## **Full texts of amendments to the proposals adopted during the forty-seventh session of the Working Party on Passive Safety**

### Amendments to Regulation No. 12

#### Amendments adopted to ECE/TRANS/WP.29/GRSP/2010/19 (see para. 16 of the report)

Figure 1: Measurement of Vb, V1, V2, V3

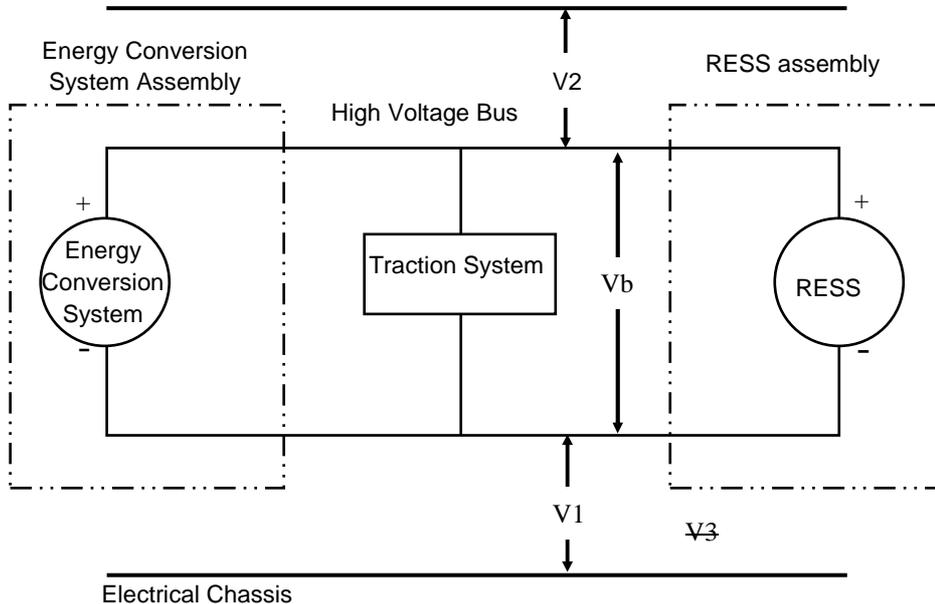
Before the vehicle **impact crash test conducted**, ~~measure and record~~ the high voltage bus voltage (Vb) (see figure 1) **shall be measured and recorded to and confirm** that it is within the operating voltage of the vehicle as ~~defined~~ **specified** by the **vehicle** manufacturer.

After the **impact** ~~crash~~ test, determine the high voltage bus voltages (Vb, V1, V2) (see figure 1). ~~If the RESS has exposed conductive parts, measure the voltage V3 between any exposed conductive parts of it and the electrical chassis.~~

**The voltage measurement shall be made not earlier than 5 seconds but not later than 60 seconds after the impact.**

**This procedure is not applicable if the test is performed under the condition where the electrical power train is not energized.**

Figure 2  
E.g. Measurement of high voltage bus energy stored in X-capacitors

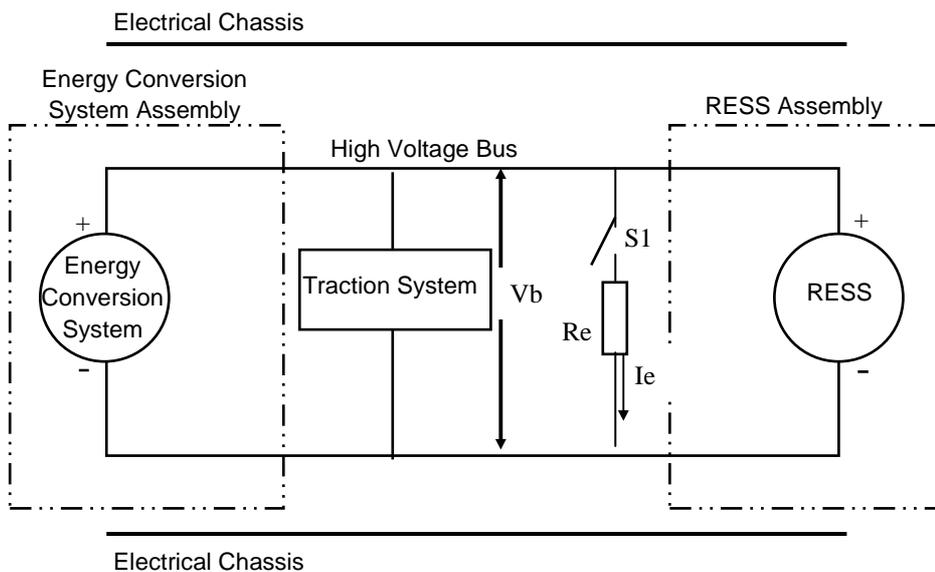
Prior to the impact a switch S1 and a known discharge resistor Re is connected in parallel to the relevant capacitance (ref. figure 2) installed according to figure 2.

When V1, V2 (see figure 1) are measured at a point in time between 5 seconds and 60 seconds after the impact and the capacitances of the Y-capacitors (Cy1, Cy2) are specified by the manufacturer, total energy (TEy1, TEy2) shall be calculated according to the following formulas:

This procedure is not applicable if the test is performed under the condition where the electrical power train is not energized.

Figure 3  
Measurement of V1'

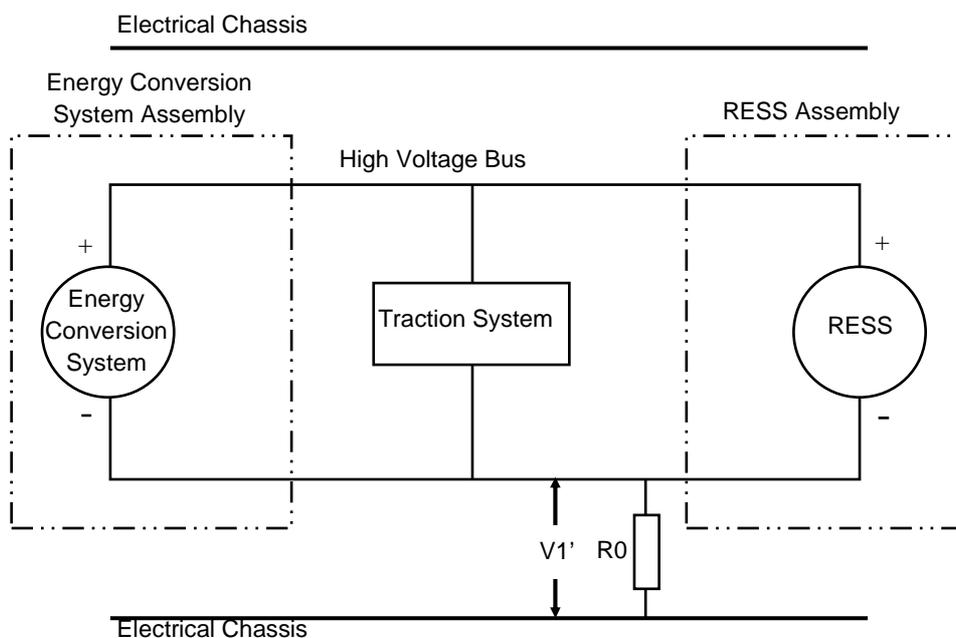
If V1 is greater than or equal to V2, insert a standard known resistance (Ro) between the negative side of the high voltage bus and the electrical chassis. With Ro installed, measure the voltage (V1') between the negative side of the high voltage bus and the vehicle electrical chassis (see figure 3). Calculate the isolation resistance (Ri) according to the formula shown **below**.

~~$$R_i = R_o * (V_b / V1' - V_b / V1) \quad \text{or} \quad R_i = R_o * V_b * (1 / V1' - 1 / V1)$$~~

Figure 1  
Jointed test finger

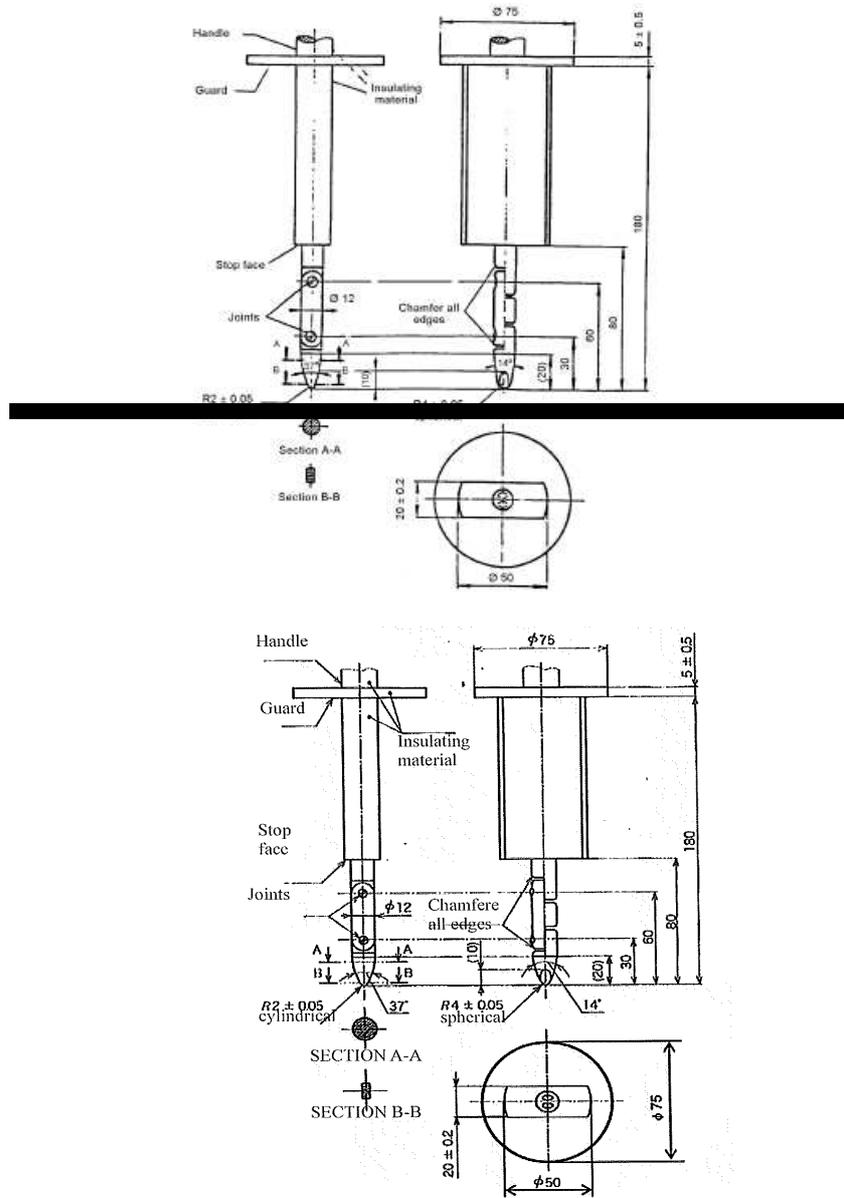
The **Jointed Test Finger** ~~access probe~~ described in Appendix 1 figure 1 is ~~pushed against~~ **shall be inserted into** any gaps or openings of the ~~[original]~~ physical protection with a ~~the~~ test force of  $10\text{ N} \pm 10\text{ per cent}$  **for electrical safety assessment**. If **partial or full penetration** ~~it partly or fully penetrates~~ into the ~~[original]~~ physical protection **by the Jointed Test Finger** occurs, ~~it is the Jointed Test Finger shall be~~ placed in every possible position as specified below.

The **requirements of paragraph 5.5.1.3 shall be considered to be met if the Jointed Test Finger** ~~access probe~~ described in Appendix 1, figure 1 ~~shall not~~ **is unable to contact touch high voltage** live parts.

Figure 1  
Measurement of Vb, V1, V2, V3

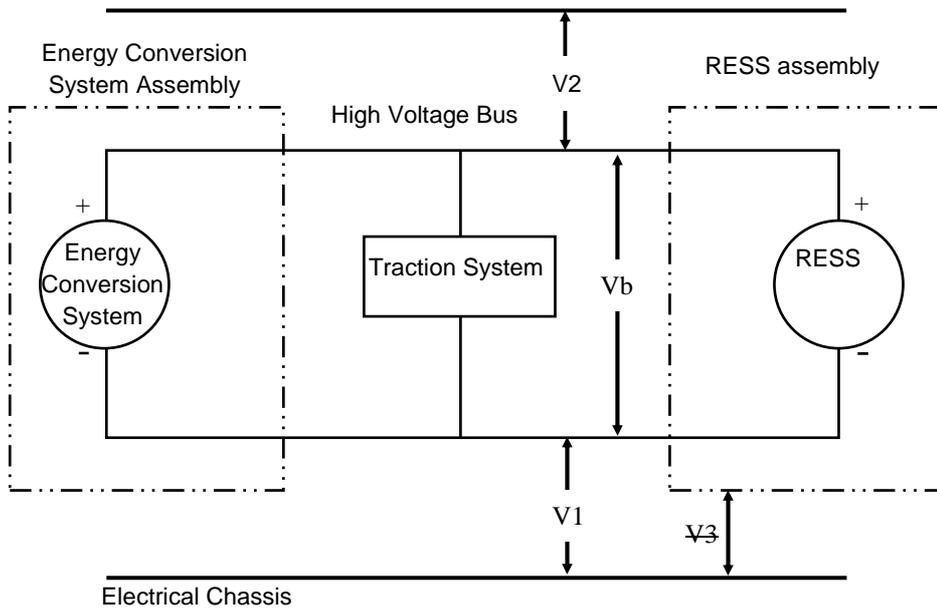
Before the vehicle ~~impact-crash test~~ **conducted**, ~~measure and record~~ the high voltage bus voltage (Vb) (see figure 1) **shall be measured and recorded to** ~~and confirm that it is~~ within the operating voltage of the vehicle as ~~defined~~ **specified** by the vehicle manufacturer.

After the ~~impact-crash~~ test, determine the high voltage bus voltages (Vb, V1, V2) (see figure 1). ~~If the RESS has exposed conductive parts, measure the voltage V3 between any exposed conductive parts of it and the electrical chassis.~~

**The voltage measurement shall be made not earlier than 5 seconds, but, not later than 60 seconds after the impact.**

**This procedure is not applicable if the test is performed under the condition where the electric power train is not energized.**

Figure 2  
E.g. Measurement of high voltage bus energy stored in X-capacitors

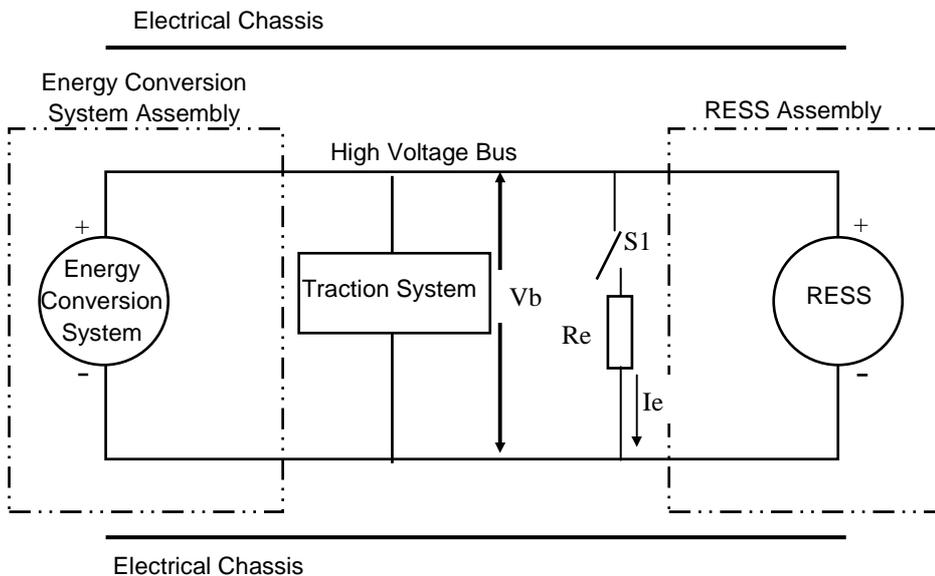
Prior to the impact a switch S1 and a known discharge resistor  $R_e$  is **connected in parallel to the relevant capacitance** (ref. figure 2), installed according to figure 2.

When  $V_1, V_2$  (see figure 1) are measured at a point in time between 5 seconds and 60 seconds after the impact and the capacitances of the Y-capacitors ( $C_{y1}, C_{y2}$ ) are specified by the manufacturer, total energy ( $TE_{y1}, TE_{y2}$ ) shall be calculated according to the following formulas:

This procedure is not applicable if the test is performed under the condition where the electric power train is not energized.

Figure 1  
**Jointed test finger**

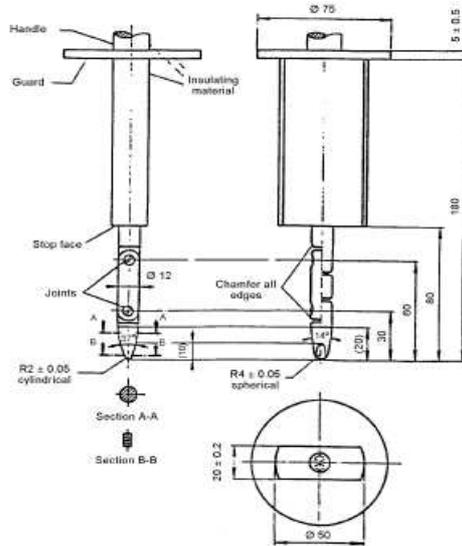
The **Jointed Test Finger** ~~access probe~~ described in Appendix 1 figure 1 is ~~pushed against~~ **shall be inserted into** any **gaps or** openings of the ~~[original]~~ physical protection with ~~a the~~ test force of 10 N ± 10 per cent **for electrical safety assessment.** If **partial or full penetration** ~~it partly or fully penetrates~~ into the ~~[original]~~ physical protection by the **Jointed Test Finger** occurs, ~~it is the~~ **Jointed Test Finger shall be** placed in every possible position as **specified below.**

The requirements of paragraph 5.2.8.1.3. shall be considered to be met if the Jointed Test Finger ~~access-probe~~ described in Appendix 1, figure 1 ~~shall not~~ is unable to contact high voltage ~~touch~~ live parts.

Figure 1  
Measurement of Vb, V1, V2V3

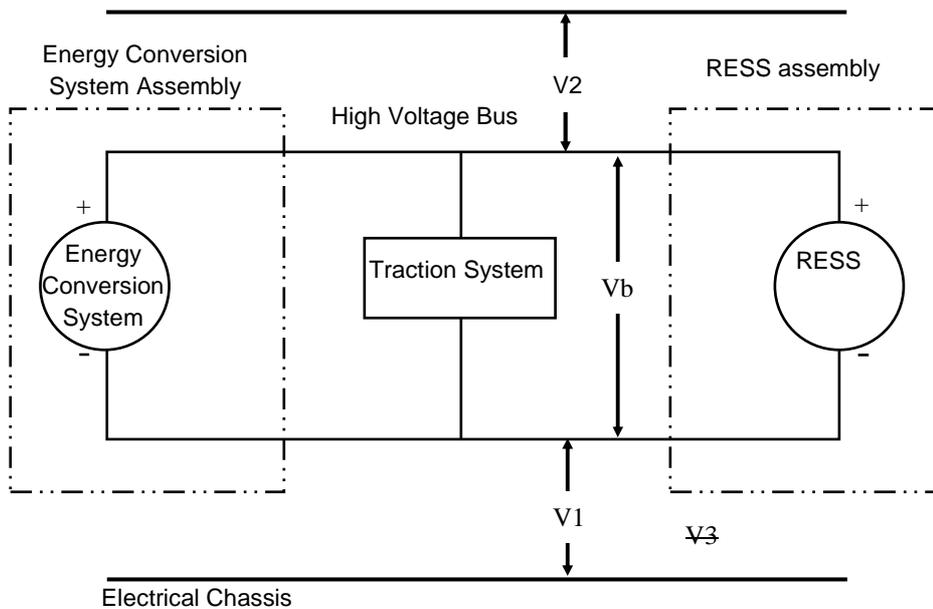
Before the vehicle ~~impact-crash~~ test **conducted, measure and record** the high voltage bus voltage (Vb) (see figure 1) **shall be measured and recorded to and confirm** that it is within the operating voltage of the vehicle as ~~defined~~ **specified** by the vehicle manufacturer.

After the **impact** crash test, determine the high voltage bus voltages (Vb, V1, V2) (see figure 1). ~~If the RESS has exposed conductive parts, measure the voltage V3 between any exposed conductive parts of it and the electrical chassis.~~

**The voltage measurement shall be made not earlier than 5 seconds, but, not later than 60 seconds after the impact.**

**This procedure is not applicable if the test is performed under the condition where the electric power train is not energized.**

Figure 2

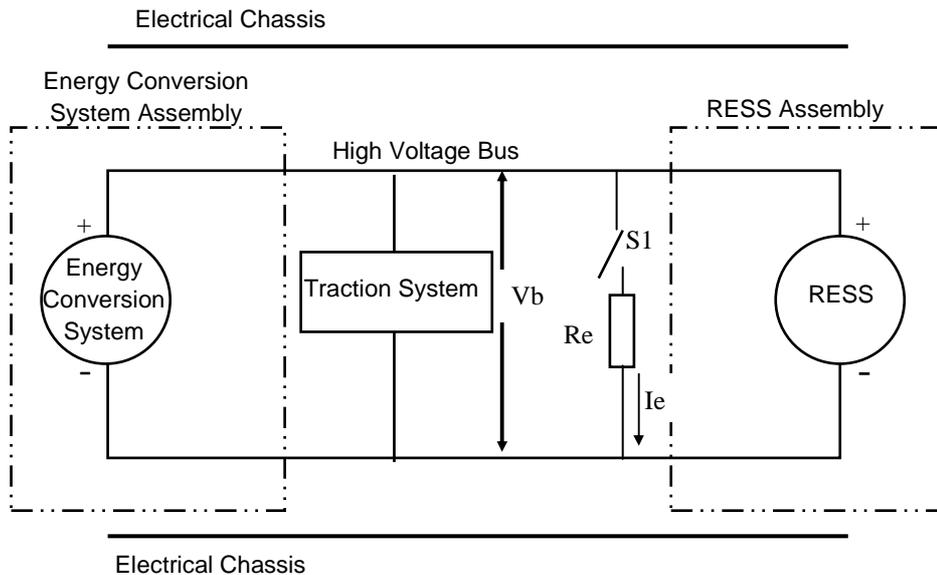
Prior to the impact a switch S1 and a known discharge resistor  $R_e$  **is connected in parallel to the relevant capacitance (ref. figure 2)**, installed according to figure 2.

When  $V_1, V_2$  (see figure 1) are measured at a point in time between 5 seconds and 60 seconds after the impact and the capacitances of the Y-capacitors ( $C_{y1}, C_{y2}$ ) are specified by the manufacturer, total energy ( $TE_{y1}, TE_{y2}$ ) shall be calculated according to the following formulas:

This procedure is not applicable if the test is performed under the condition where the electric power train is not energized.

Figure 1  
**Jointed test finger**

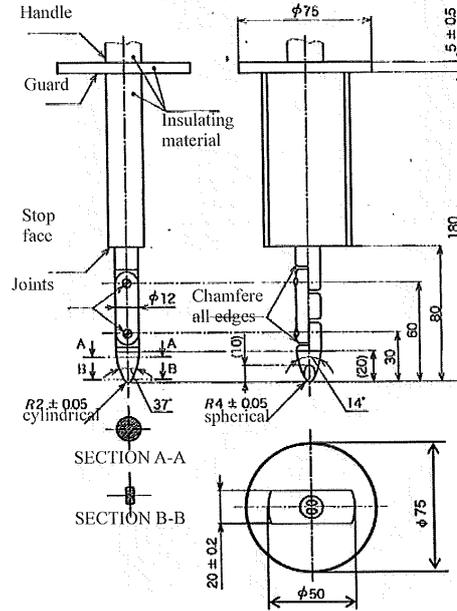
The **Jointed Test Finger** ~~access probe~~ described in Appendix 1 figure 1 ~~is pushed against~~ **shall be inserted into** any gaps or openings of the ~~[original]~~ physical protection with a ~~the~~ test force of  $10\text{ N} \pm 10$  per cent **for electrical safety assessment**. If **partial or full penetration** ~~it partly or fully penetrates~~ into the ~~[original]~~ physical protection **by the Jointed Test Finger** occurs, ~~it is the~~ **Jointed Test Finger shall be** placed in every possible position as **specified below**.

The **requirements of paragraph 5.3.6.1.3. shall be considered to be met if the Jointed Test Finger** ~~access probe~~ described in Appendix 1, figure 1 ~~shall not~~ **is unable to contact high voltage** ~~touch~~ live parts.
